**Subject: National Pollutant Discharge Elimination System (NPDES)  
Notice of General Permit Coverage (NGPC)  
Coco Palms Resort  
4-241 Kuhio Highway  
Kapaa, Island of Kauai, Hawaii  
File No. HIR10H353**

**Hawaii Department of Health  
Clean Water Branch  
National Pollutant Discharge Elimination System (NPDES)  
Construction Storm Water Inspection Report**

**Inspection Report Number:** PA2142

**Photograph 15.**

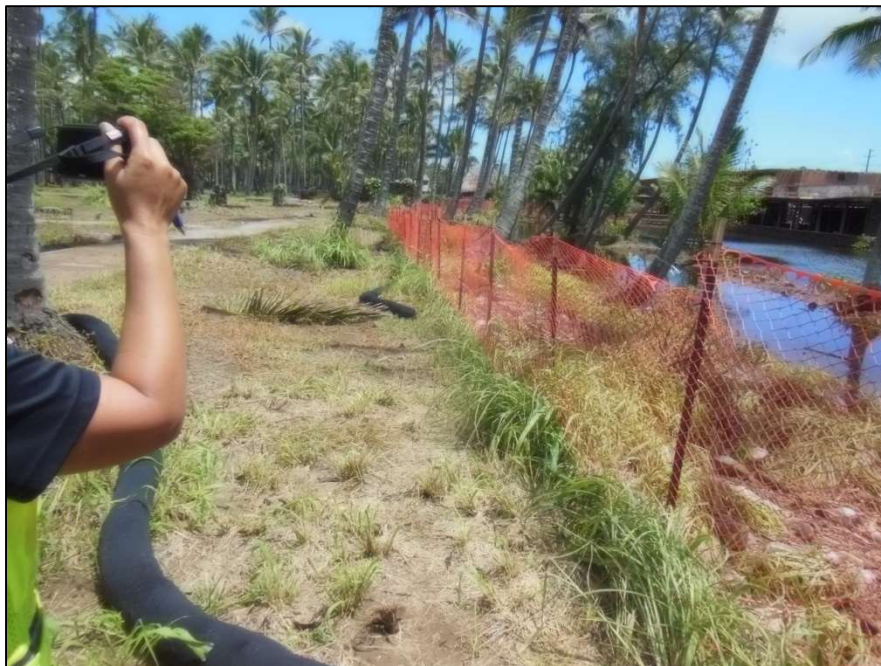
Description: View, facing southeast, of the southwestern perimeter of the Site. Perimeter controls were not observed installed along this section of the perimeter.

**Photograph 27.**

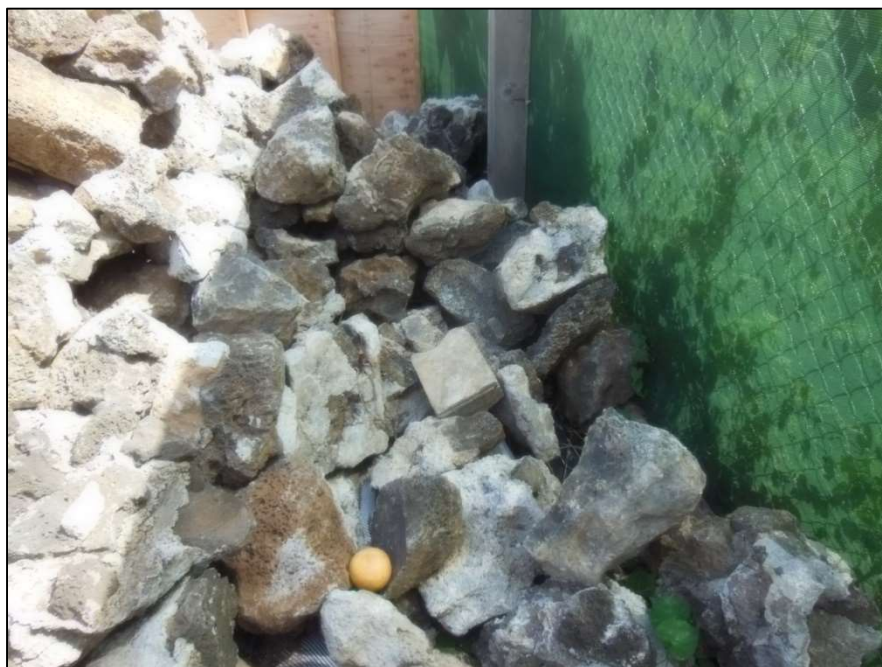
Description: View, facing west, of the northern perimeter of the Site. Note the rock stockpile overtopping the straw wattle (red arrow).
